KINGSTON STEAM PLANT - ANNUAL ASH DISPOSAL AREA INSPECTION

ANNUAL ASH DISPOSAL AREA INSPECTION

PROJECT: KINGSTON STEAM PLANT

DATE: September 8, 1972

SECTION THROUGH NORTH DIKE AND STORAGE AREA
NTS

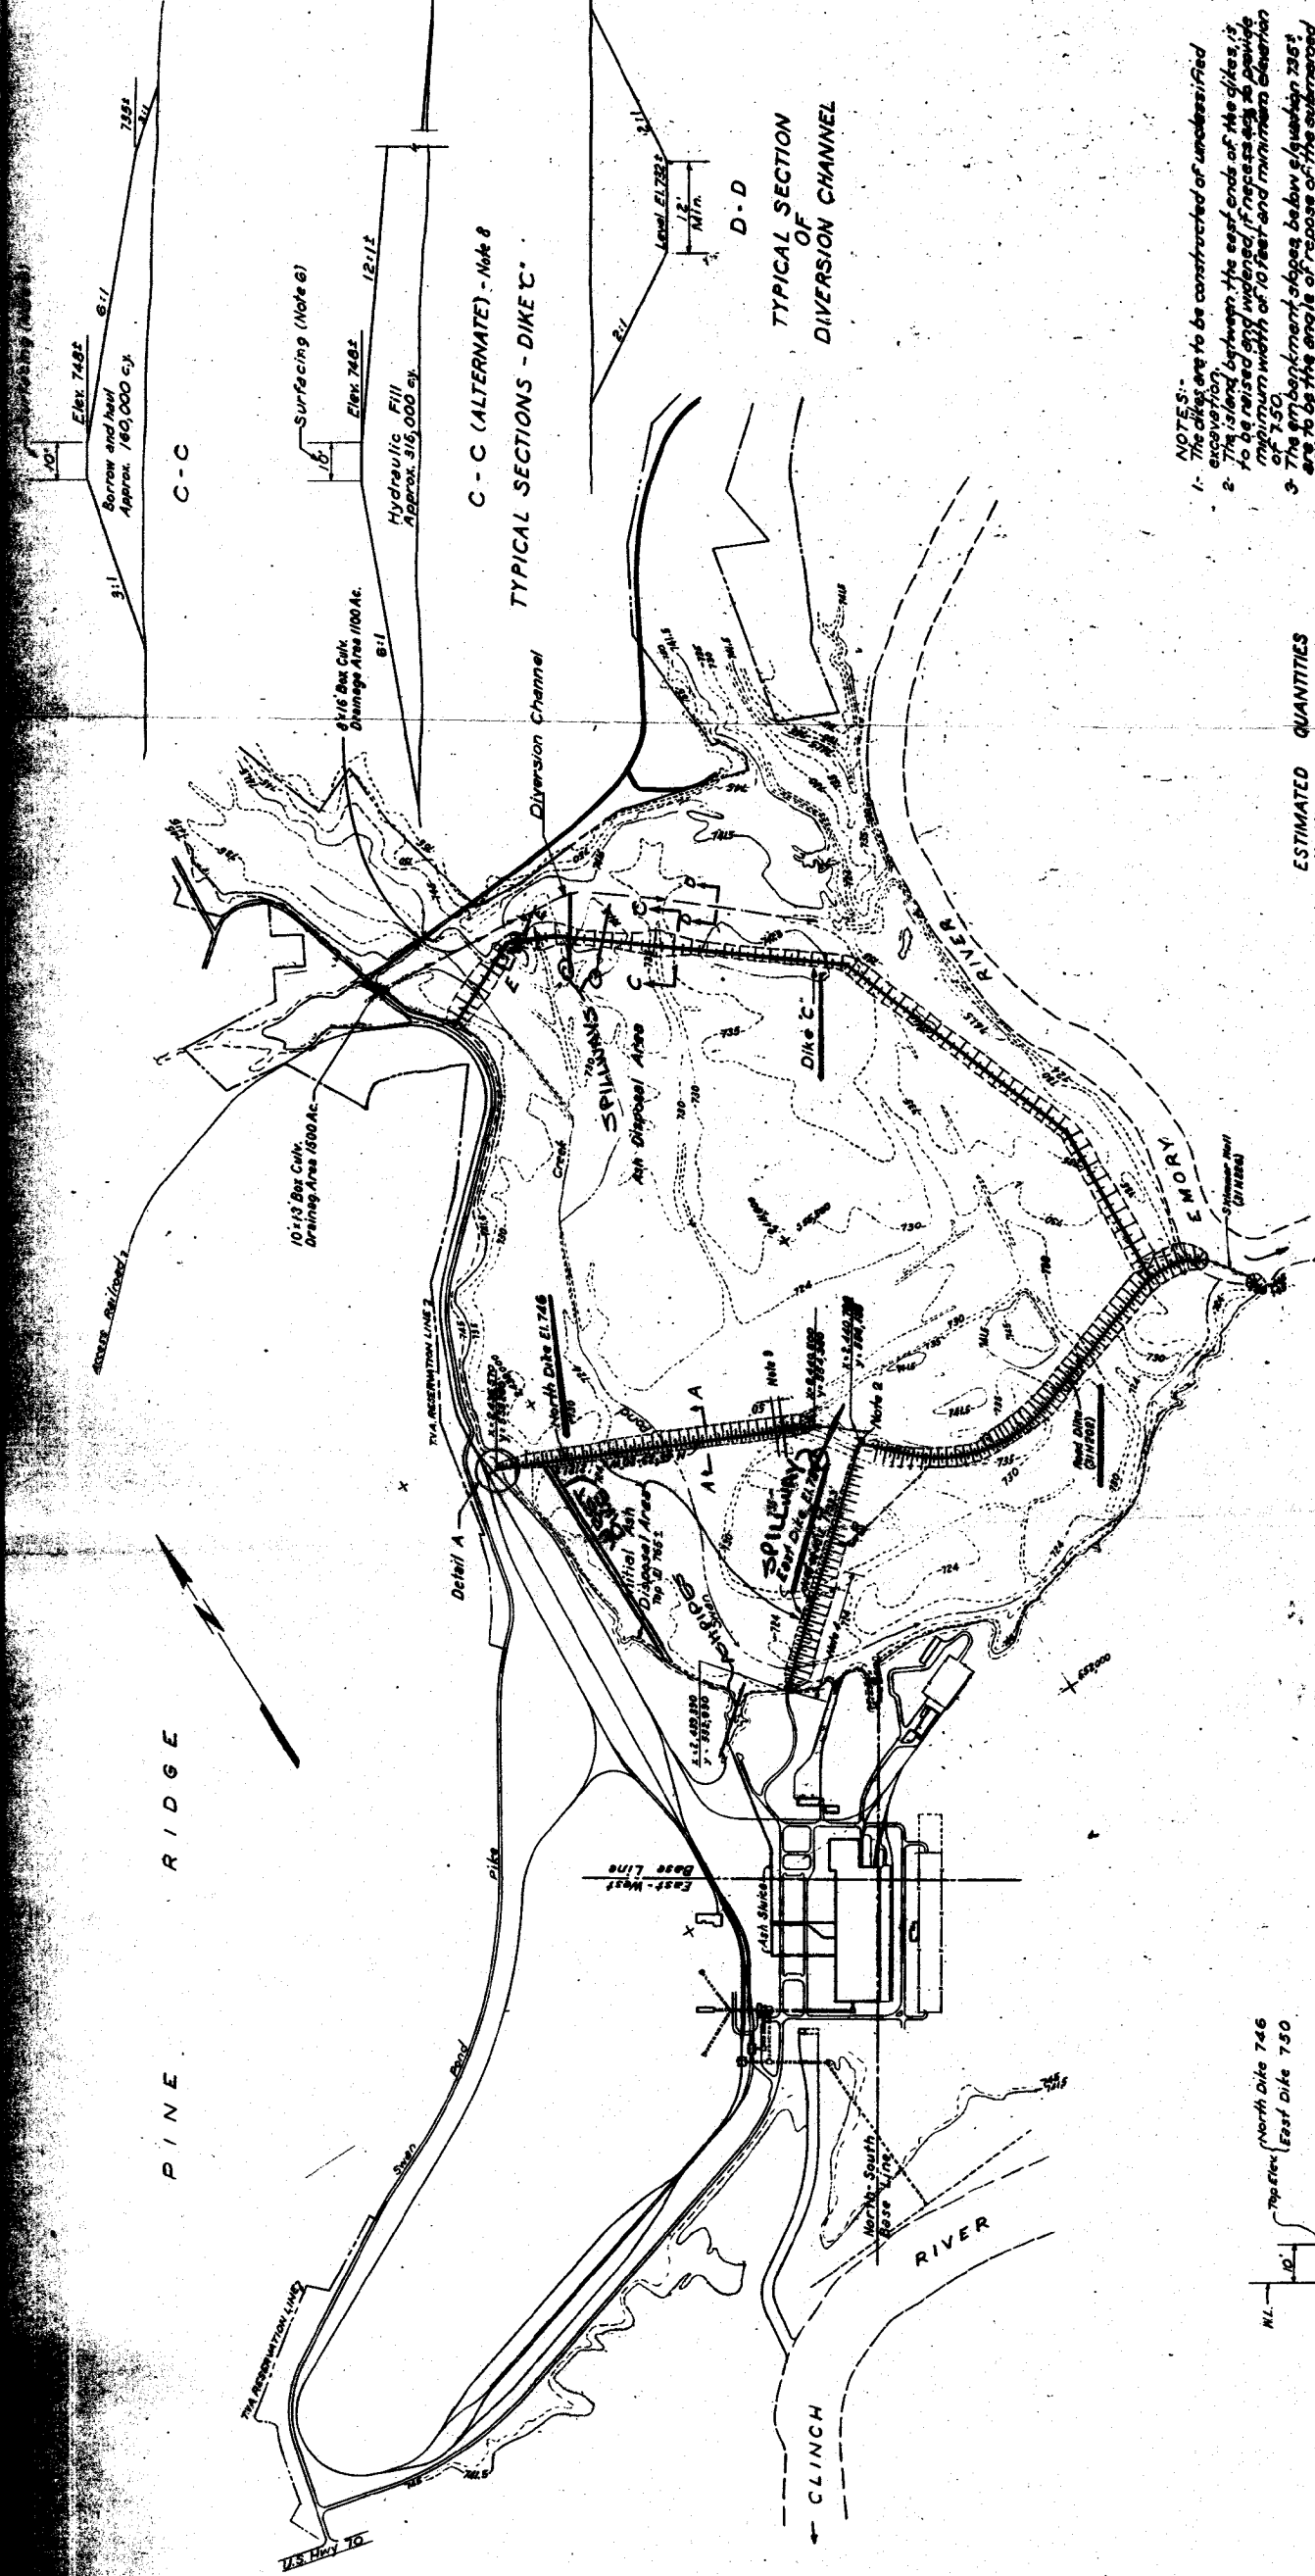
Ash is sluiced into the initial area, then dry hauled to the area adjacent to the north dike where it is deposited in stages (see attached sketch). As each stage reaches the elevation of the top of the north dike, it is covered with earth and seeded. Each stage is approximately the same length as the north dike.

Note: Stage 4 will be covered with soil fertilized, Lime and seeded when final Elevation is Reached.
